PLANNING AND ZONING COMMISSION AGENDA

REGULAR MEETING | JULY 23, 2026 AT 6:00 PM
CITY HALL COUNCIL CHAMBERS | 405 MUNICIPAL DRIVE, KENNEDALE, TX 76060

**STAFF REPORT
TO THE PLANNING AND ZONING COMMISSION**

JN 19-015-FP

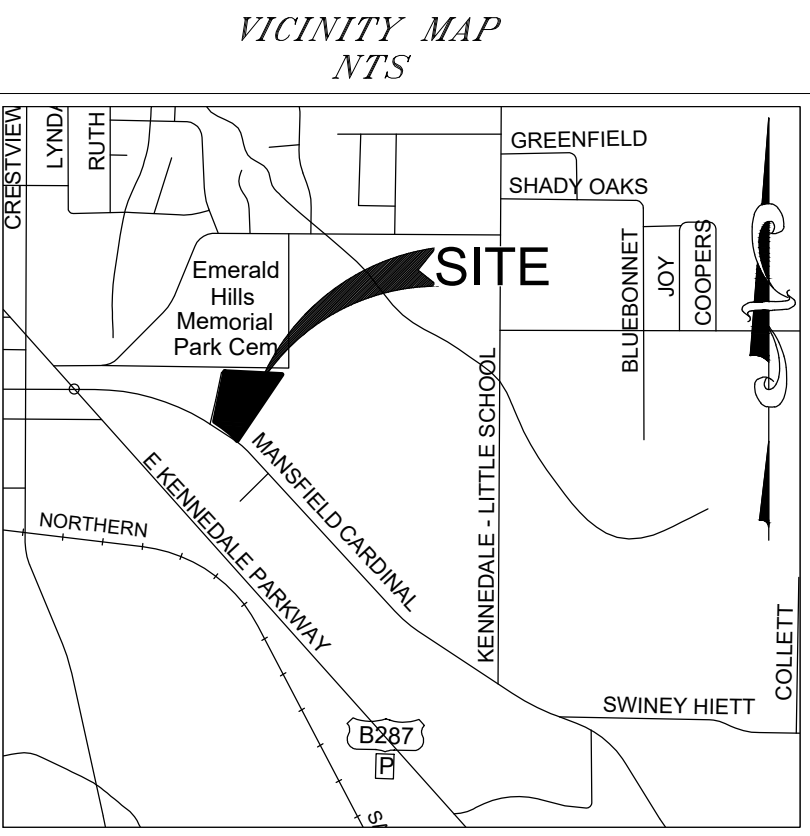
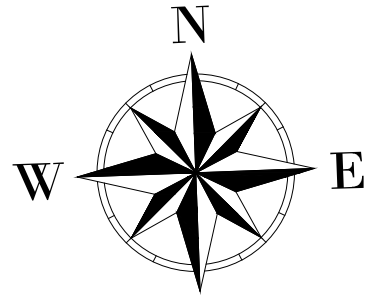
(Informational) For addressing purposes,
Please show and label a proposed name
for the shown 24' access easement and
note on that this will be a "Private Street".

A) (Action) A 40' wide looping private access easement for vehicular travel with a sidewalk is required to transit through this development as established in Ordinance 758 Section IV Subsection H. The proposed 24' access easement is insufficient to meet this standard. Correct as appropriate.

B) (Action) An existing "45' Right of Way Easement" is shown to be abandoned on the east side of this site. Clarify the status of this easement and what parties may have rights or interests in its use.

C) (Conditional) If the easement referred to in Item B above would isolate off-site properties from a public roadway, or parties with a legal interest would be damaged by such abandonment this must be addressed prior to the filing of the plat. Additionally, if said easement was dedicated to the public in general or to the City additional steps may be needed to effect this change (COK UDC 26.22)

(Action) Add a note to the face of the plat stating, "Lots 40 and 41 are private common areas to be owned and maintained by an HOA for common and drainage, purposes. The City shall retain a right of entry and a right, but not an obligation, to maintain these areas as necessary for public health, safety, or welfare. The City may assess costs thus incurred on an HOA or owners who have not adequately maintained them."

(Action) Change the shown Note 5 on the face of the plat to read "Development of this property is subject to the City of Kennedale Unified Development Ordinance and PD-TH zoning established by Ordinance 758."

(Action) Add or modify (as needed), a standard City Council Approval Box being no greater than two (2) inches high and four and one-half (4 1/2) inches wide containing the following information:

(Action) Add a note to the face of the plat stating, "This plat does not amend or remove any covenants or deed restrictions".

(Action) The PD for this site (Established with Ordinance # 758), requires a continuous looping sidewalk to be located within a 40' wide private "firelane and access" easement. (See Exhibit B Section IV Subsection H). The provided "access" easement shown is only 24' wide. Correct as needed.

(Action) Ordinance 758 establish a minimum average lot size of 5,450 square feet. The provided residential lots as shown yield an average lot size of only 4,838.949 square feet. Correct as needed by increasing lot sizes.

C) (Conditional) If the plat name is not changed as suggested in item B above change ... "LOT'S 2-39" to "LOTS 2-39" as a grammatic correction.

25, 31, 32, 35, and 36 the remaining residential lots do not appear to meet the minimum 35' lot width standard at the Setback Line established in Ordinance 758 Exhibit B. Section III Subsection B) 12. Correct as needed and provide a table indicating the specific width, depth, and area of each residential lot or label this on the graphic.
